**RIDGE FARM
FINAL PLAN PHASE 1B
MAJOR PLAN 2017-101**

**SUBJECT: RIDGE FARM FINAL PLAN PHASE 1B
MAJOR PLAN 2017-101
REQUEST FOR FINAL PLAN REVIEW**

SUBJECT: South Whitehall Township
Ridge Farms
Major Subdivision #2017-101
Phase 1B Final Plan Review

**Re: Ridge Farms Final Plan Phase 1B
Major Subdivision #2017-101
Final Land Development Plan Review**

Drawing Title: **EXISTING FEATURES PLAN**

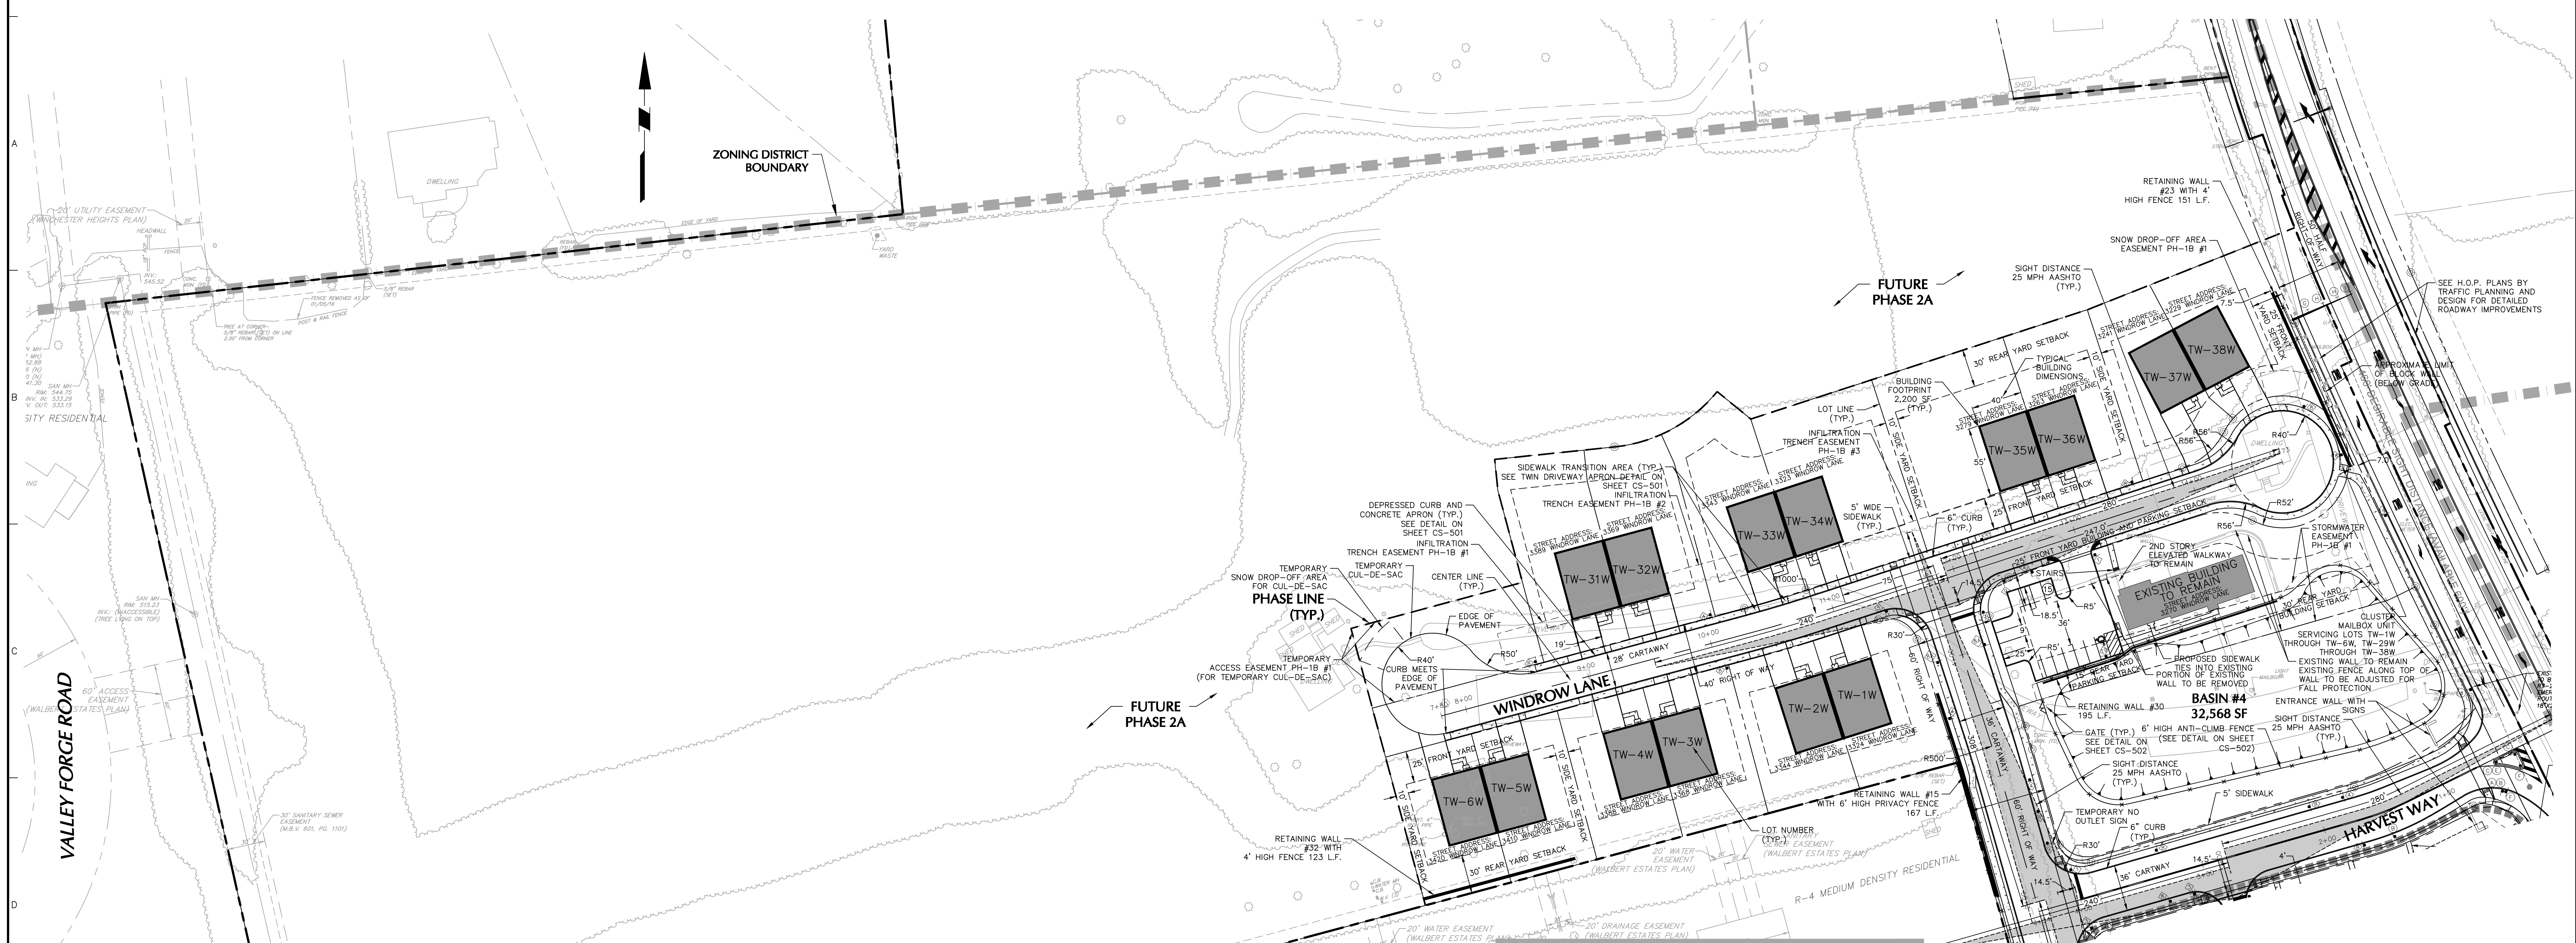
1. **Sheet 3 Drawing VT-101 Existing Features:** Must show private 8" water line from Yellow Stone Rd to all existing buildings.
2. **Utility Plan CU-101 Sheet 14 of 22: Utility Note #26 Shall read** Underground warning tape shall be installed a minimum of two feet above any pipe in the backfill of any mainline or lateral trench. Tape shall be alkali resistant, 4mils polyethylene, 4 inches minimum width, continuously printed with name or symbol of utility buried below, color coded as follows. Blue: Water system/Green: Sewer systems.

1. **Sheet 3 Drawing VT-101 Existing Features:** Must show private 8" water line from Yellow Stone Rd to all Jeras Corp. existing buildings.

DRAWING TITLE
UTILITY PLAN

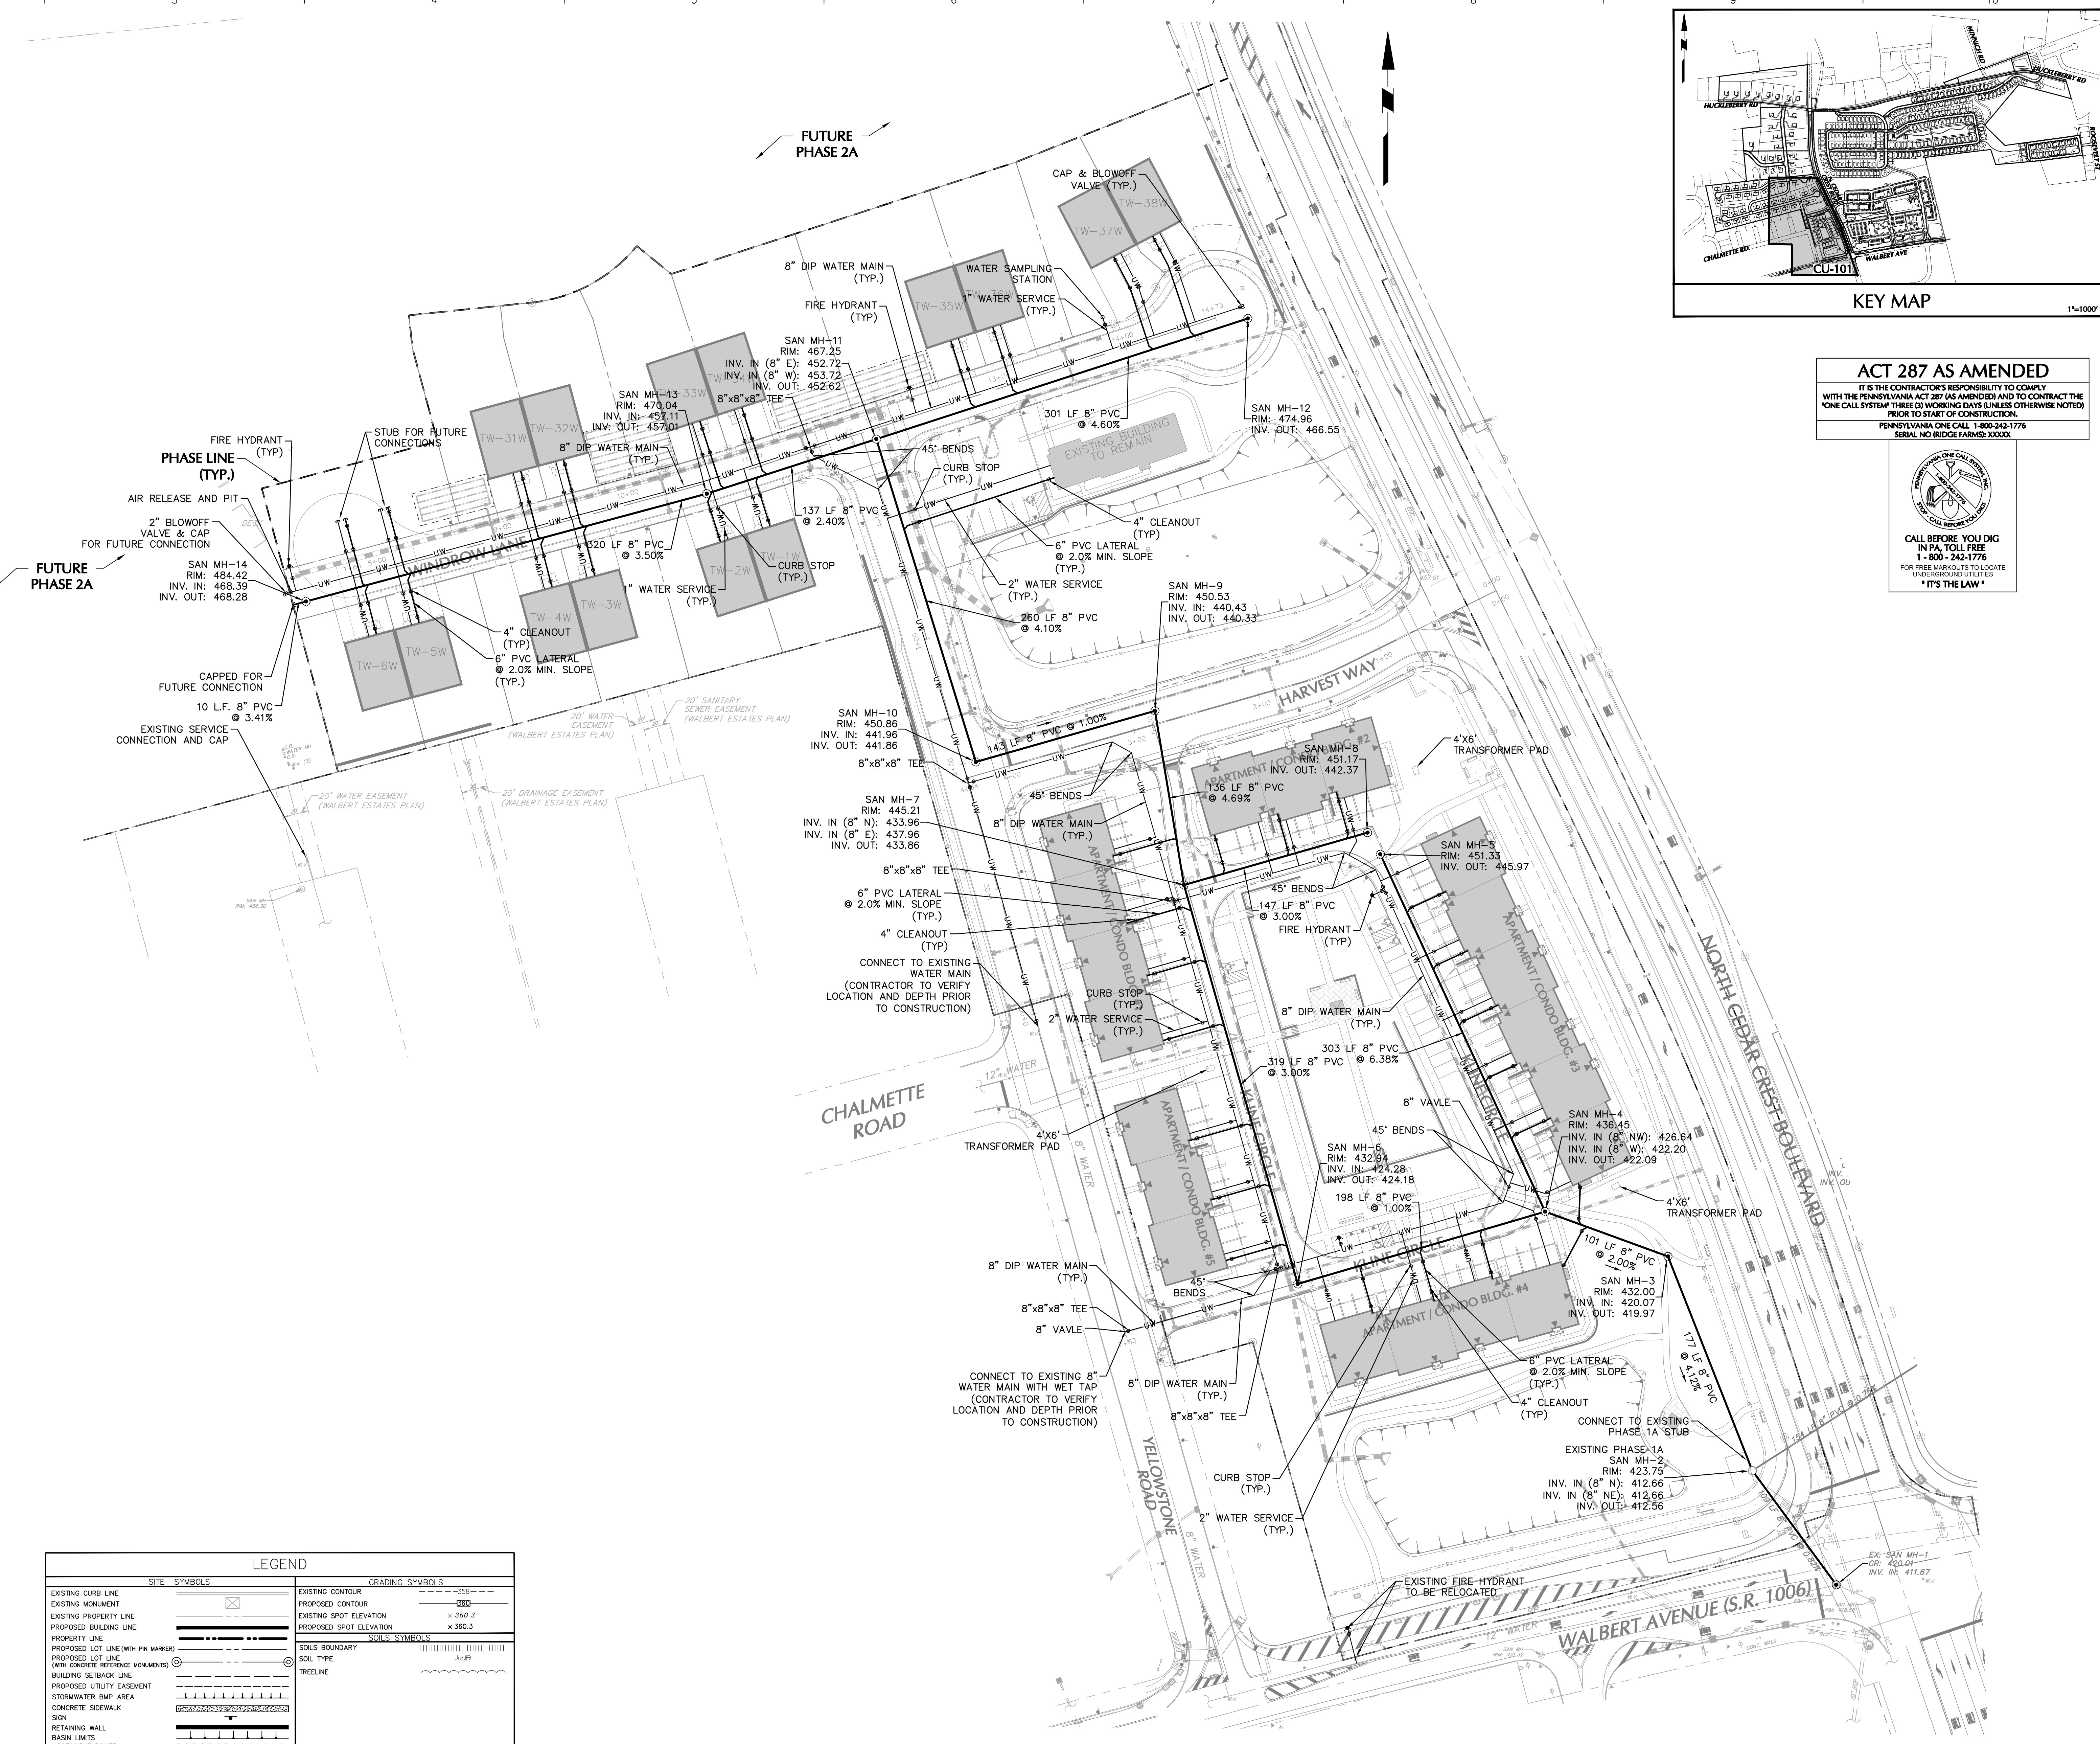
3. **Utility Plan CU-101 Sheet 14 of 22: Utility Trench Excavation Guidelines:** Add Note – Utility Trench Excavation Shall be in accordance with South Whitehall Technical Specifications Water mains and Appurtenances/Sanitary Sewers and Appurtenances.

4. **Utility Plan CU-101 Sheet 14 of 22: Utility Note #3** Change wording [Old private 6" water line] New wording - Old private 8" water line and appurtenances.
